ADDENDUM # 5 Bid 20C6, Waverly Elementary School - New Construction

ADDENDUM NO. 5

RE: **WAVERLEY ELEMENTARY SCHOOL REPLACEMENT**

This addendum forms a part of the Contract Documents and modifies the original Bidding Documents dated March 16, 2020. Acknowledge receipt of this Addendum in the space provided on the Form of Proposal.

ADD5.1 1 1/2" = 1'-0"
DETAIL 10/A6.16

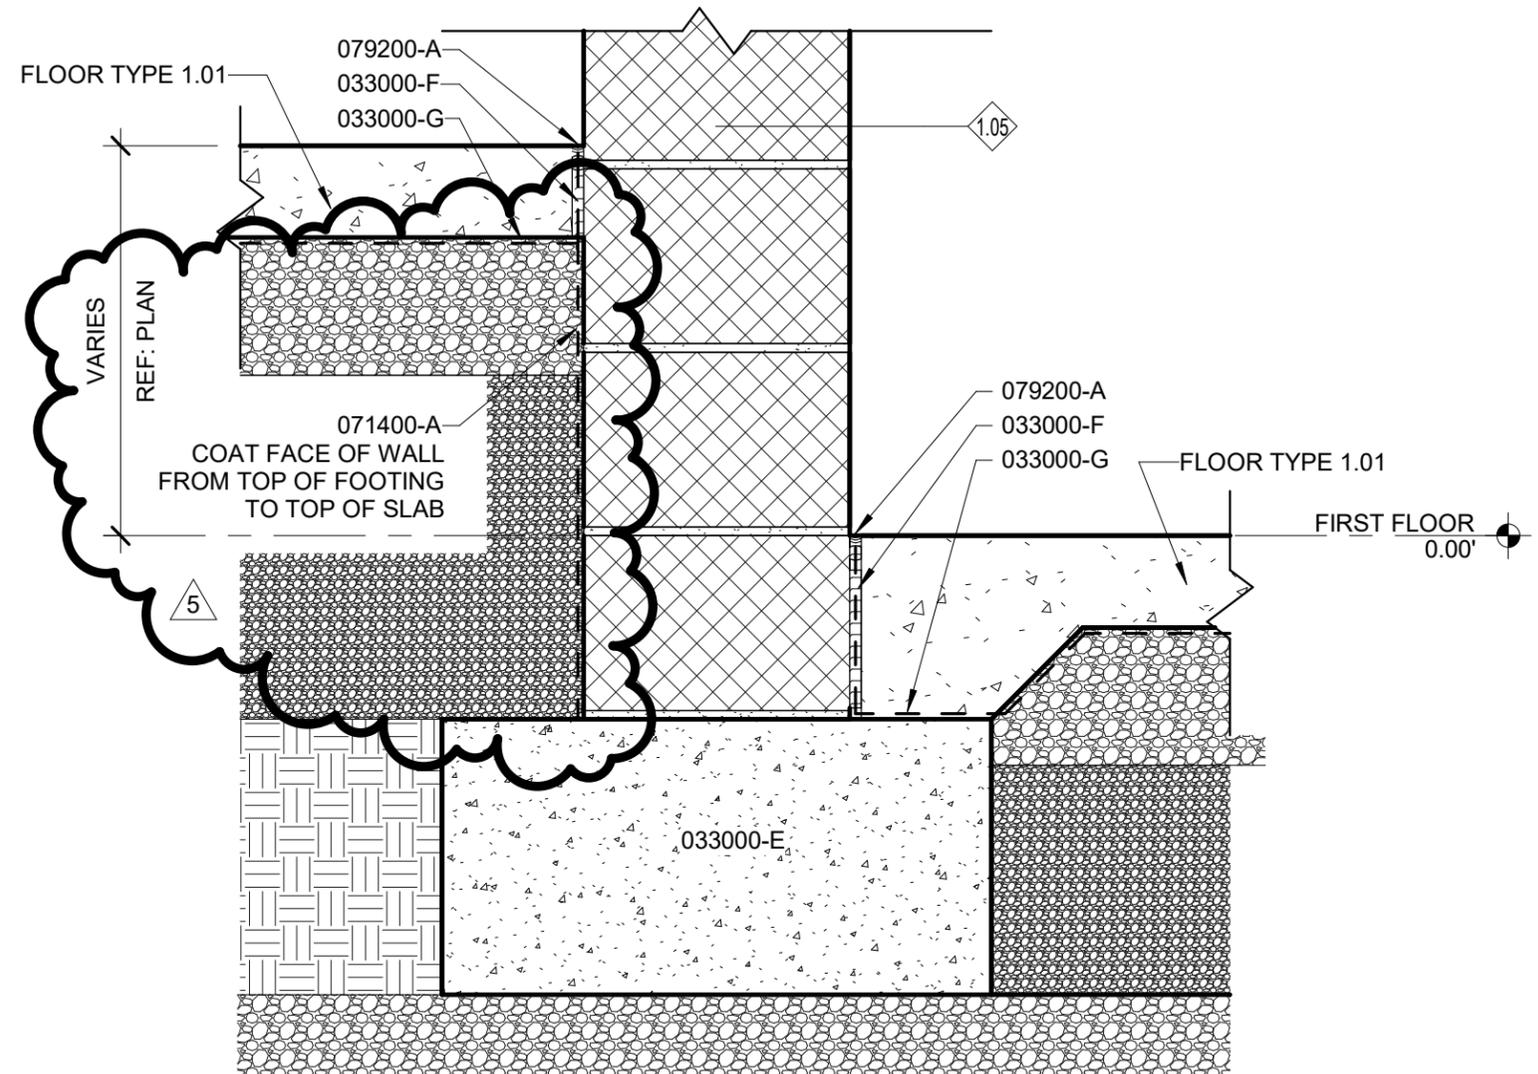
17. **REVISE** Drawing Sheet A6.16 – SECTION DETAILS; Issued for Bid, dated 03/06/2020.
 - **REVISE** detail 3 as indicated in Sketch ADD5.2 issued as part of this addendum.
 - **REVISE** detail 7 as indicated in Sketch ADD5.2 issued as part of this addendum.
 - **REVISE** detail 10 as indicated in Sketch ADD5.1 issued as part of this addendum.
18. **REVISE** Drawing Sheet A6.17 – SECTION DETAILS; Issued for Bid, dated 03/06/2020.
 - **REVISE** detail 9 as indicated in Sketch ADD5.1 issued as part of this addendum.
19. **REVISE** Drawing Sheet A7.3 – ENLARGED PLANS & INTERIOR ELEVATIONS; Issued for Bid, dated 03/06/2020.
 - **REVISE** all instances of “Ceiling Type 1.12” to be “Ceiling Type 1.11”.

1 SECTION DETAIL
 ADD5.3 1 1/2" = 1'-0"
 DETAIL 10/A6.12

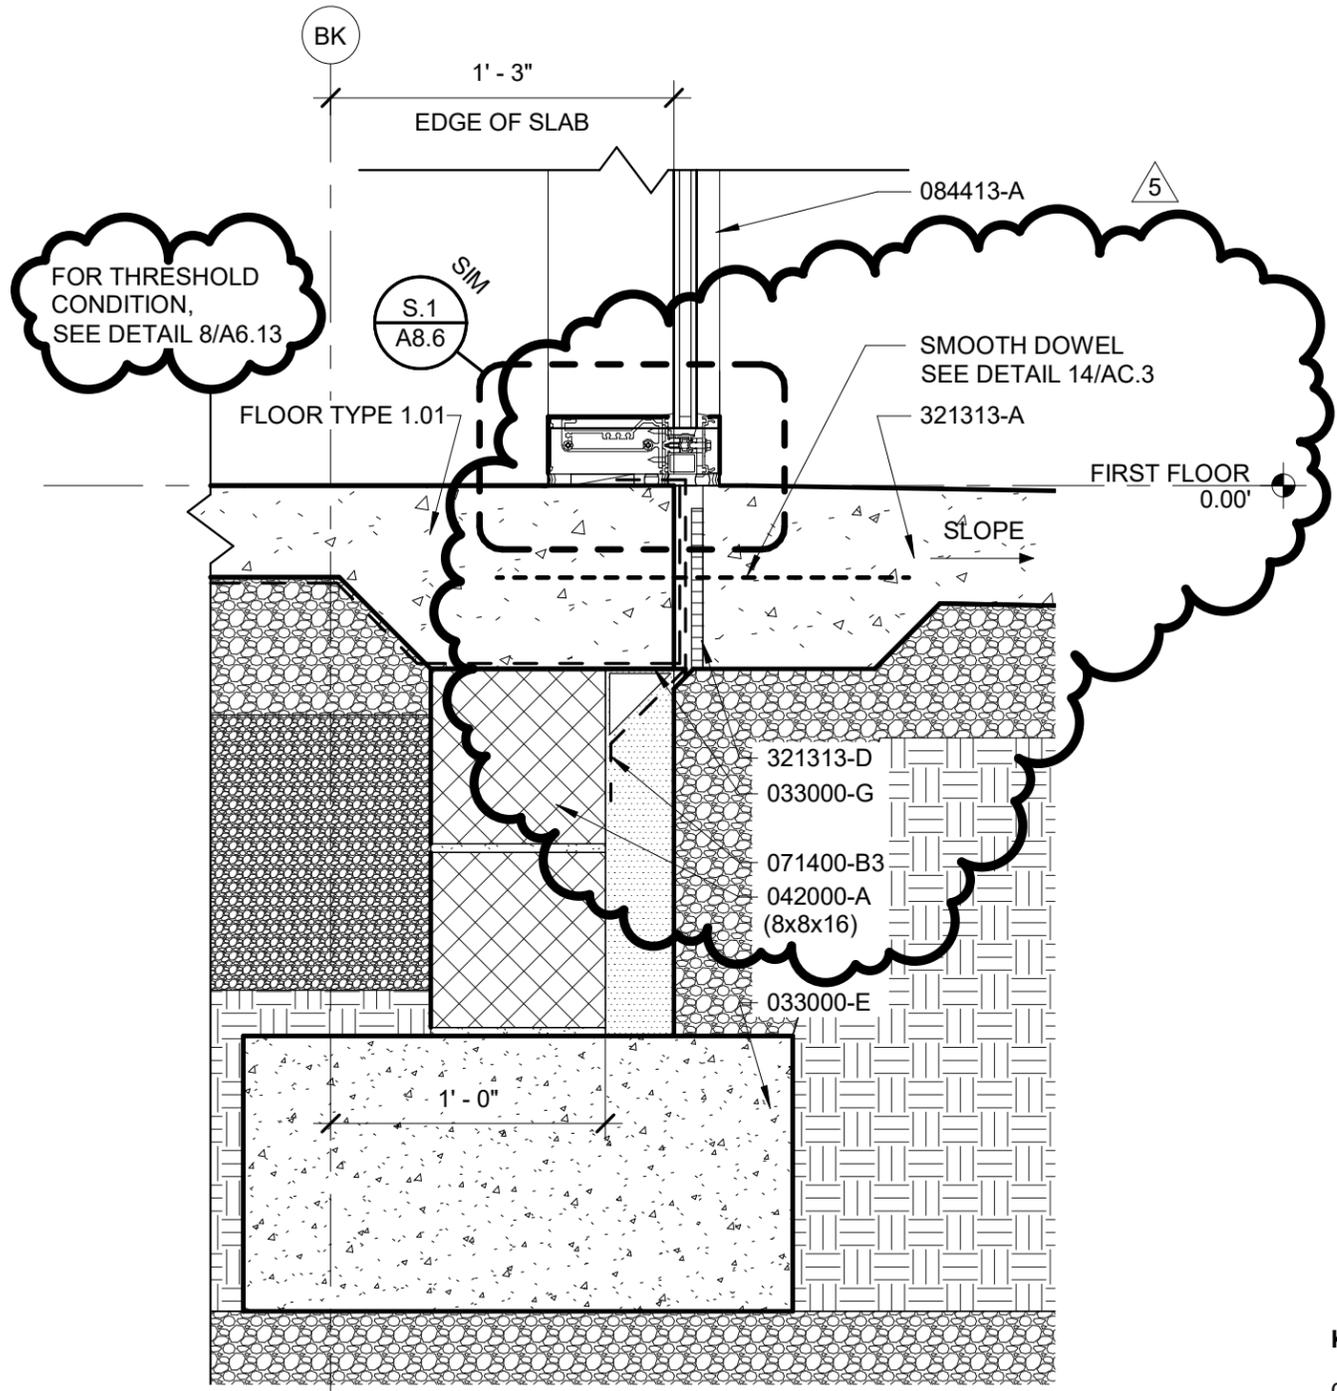
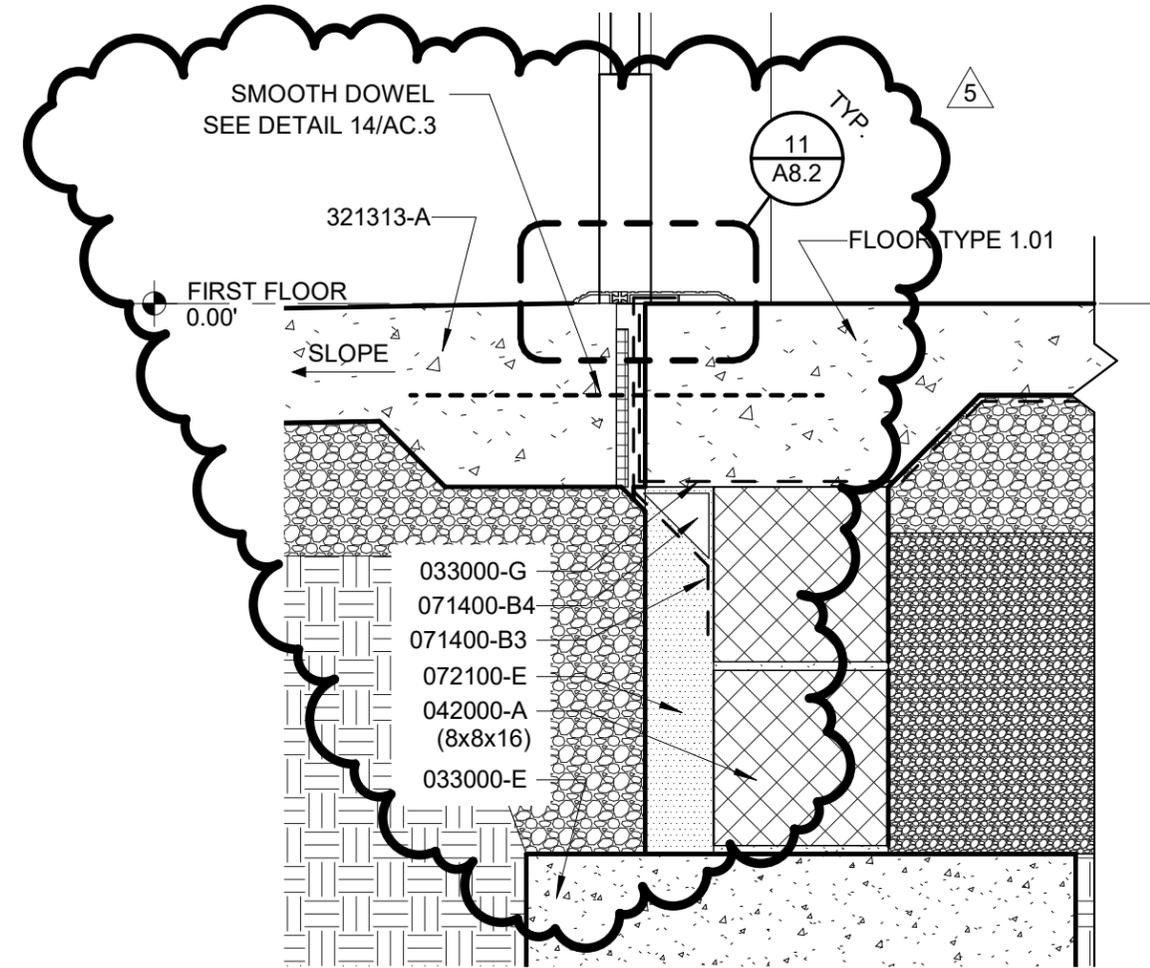
- **REVISE** detail 6 as indicated in Sketch ADD5.4 issued as part of this addendum.
 - **REVISE** detail 10 as indicated in Sketch ADD5.3 issued as part of this addendum.

- **REVISE** detail 8 as indicated in Sketch ADD5.3 issued as part of this addendum.

1 SECTION DETAIL
 ADD5.5 1 1/2" = 1'-0"
 DETAIL 1/A6.12

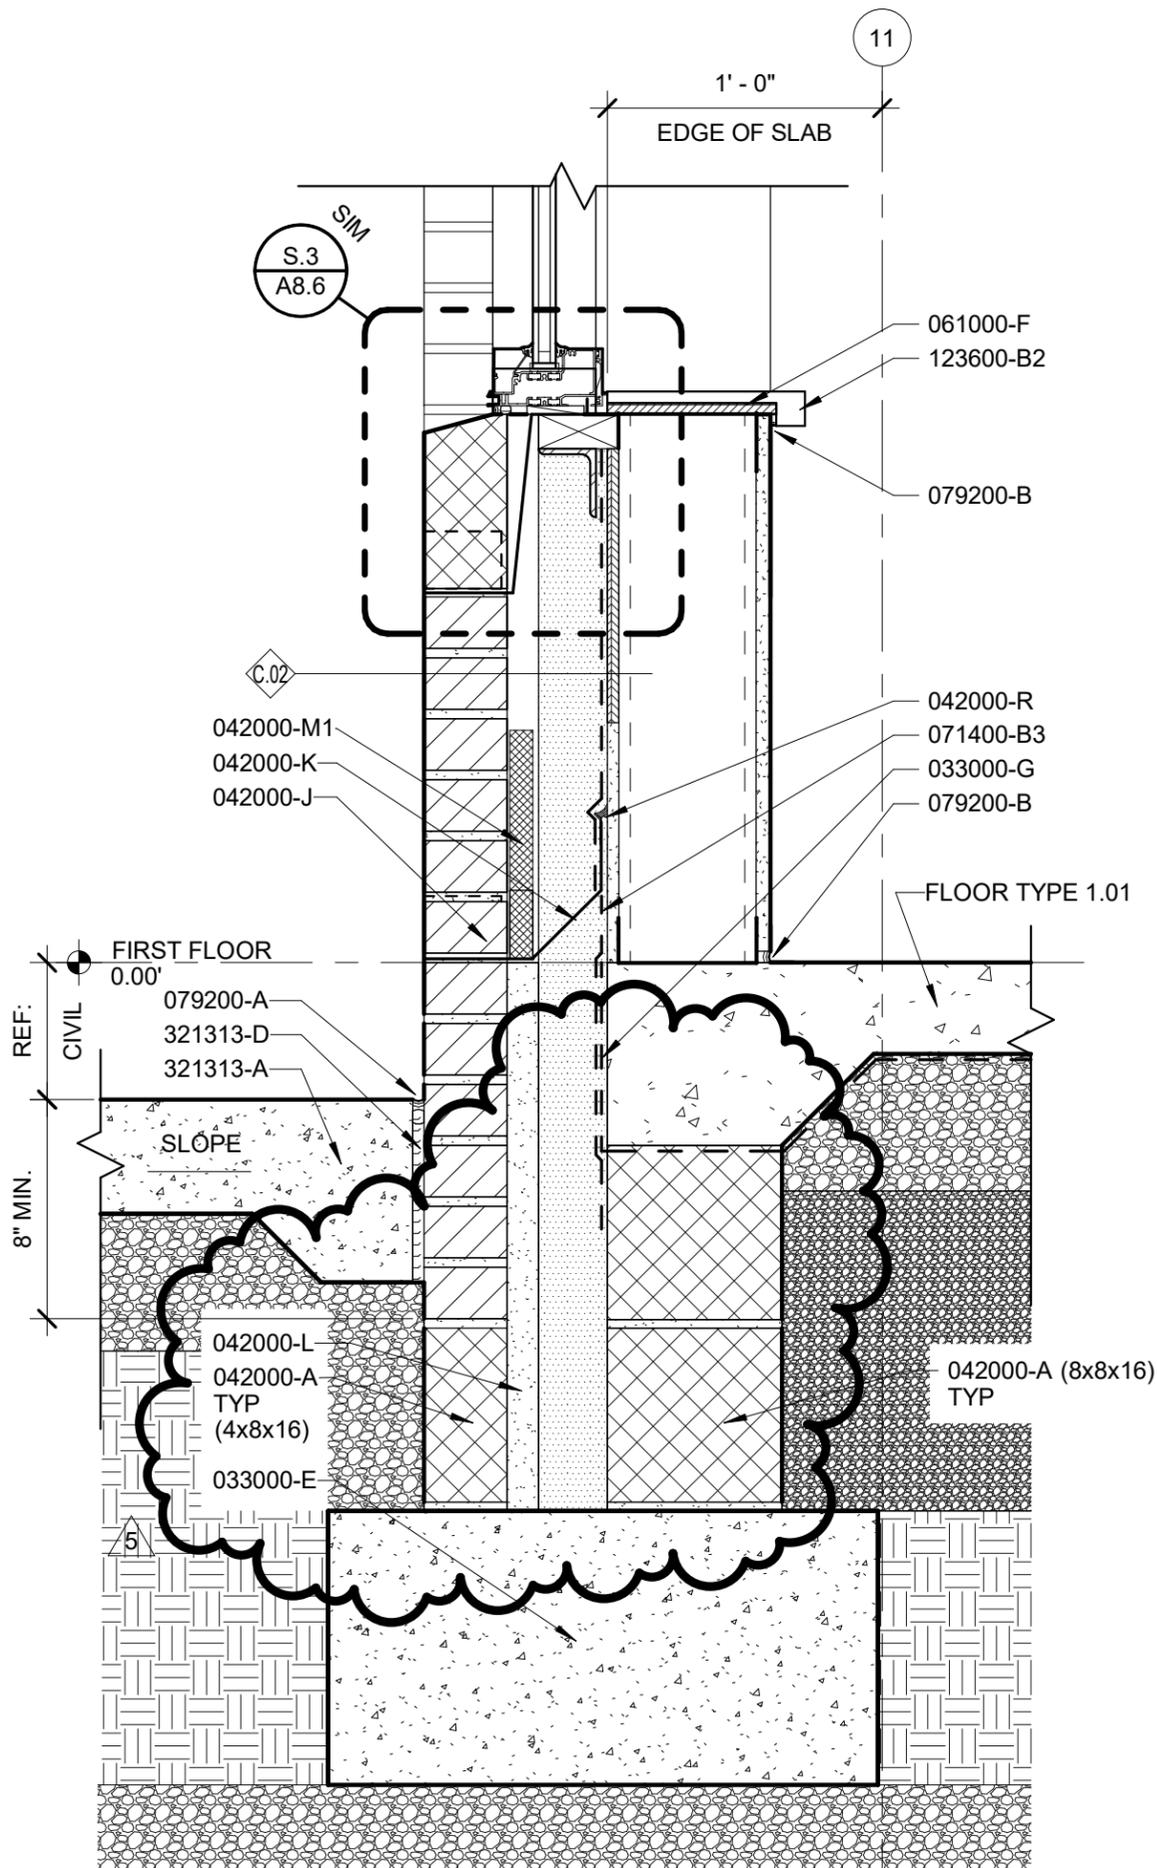
- **REVISE** detail 1 as indicated in Sketch ADD5.5 issued as part of this addendum.
 - **REVISE** detail 5 as indicated in Sketch ADD5.6 issued as part of this addendum.

ADD5.7 1 1/2" = 1'-0"
DETAIL 10/A6.11

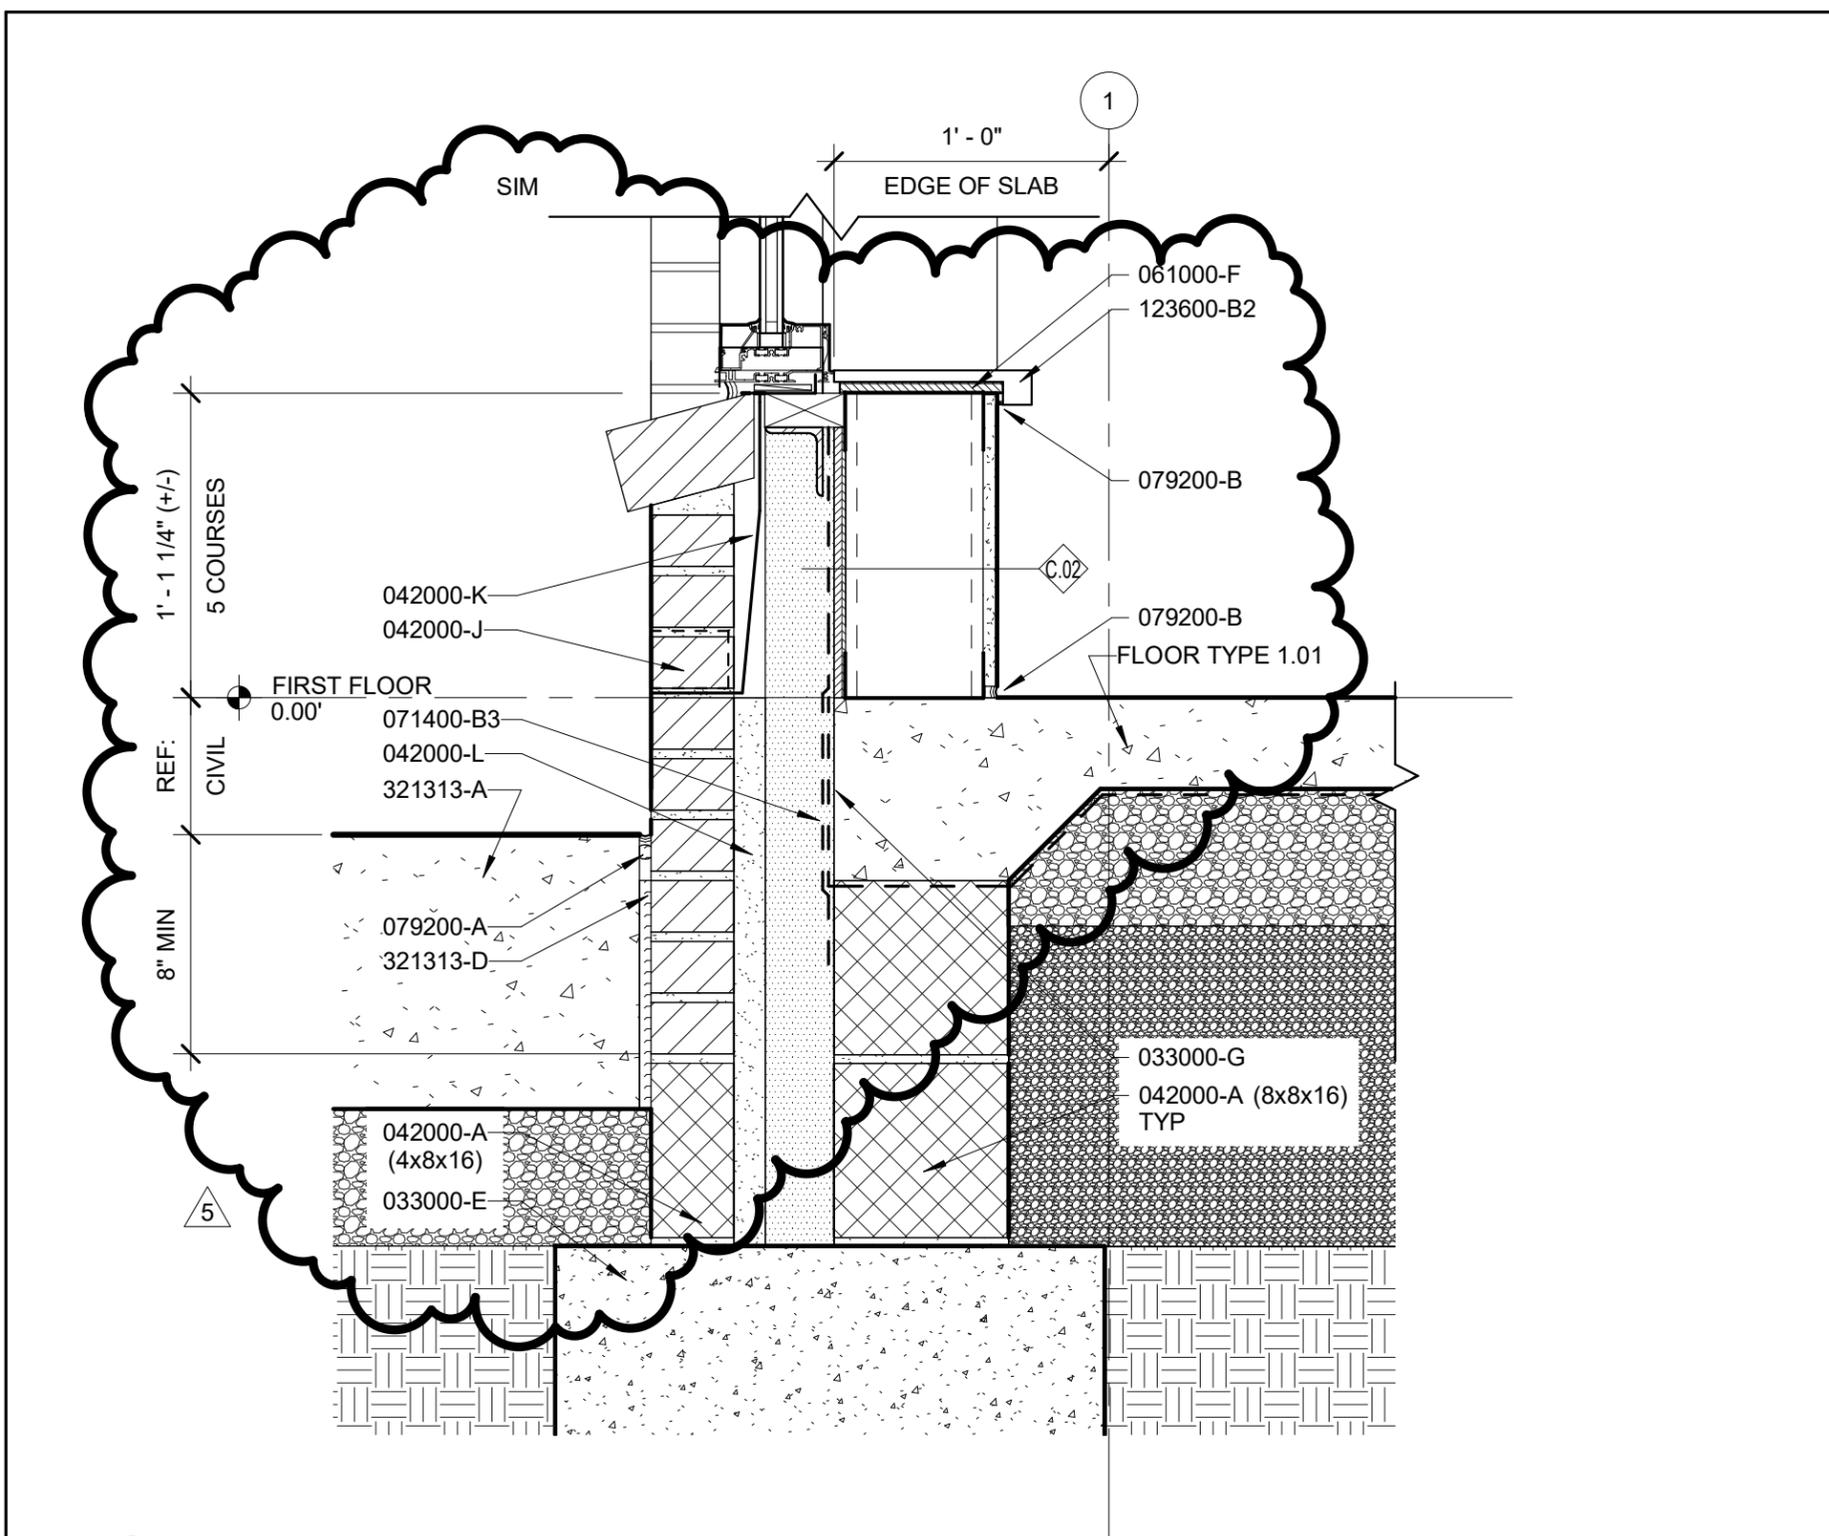
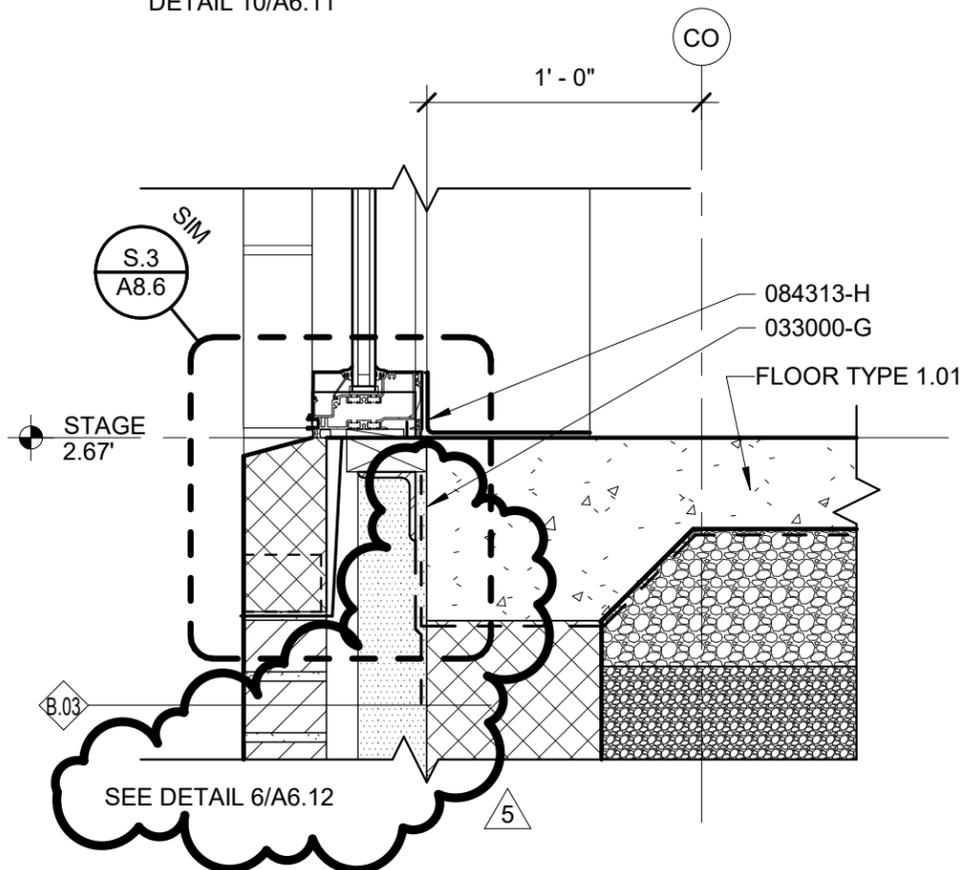
- **REVISE** detail 9 as indicated in Sketch ADD5.9 issued as part of this addendum.
 - **REVISE** detail 10 as indicated in Sketch ADD5.7 issued as part of this addendum.

- **REVISE** detail 12 as indicated in Sketch ADD5.7 issued as part of this addendum.
16. **REVISE** Drawing Sheet A6.13 – SECTION DETAILS; Issued for Bid, dated 03/06/2020.
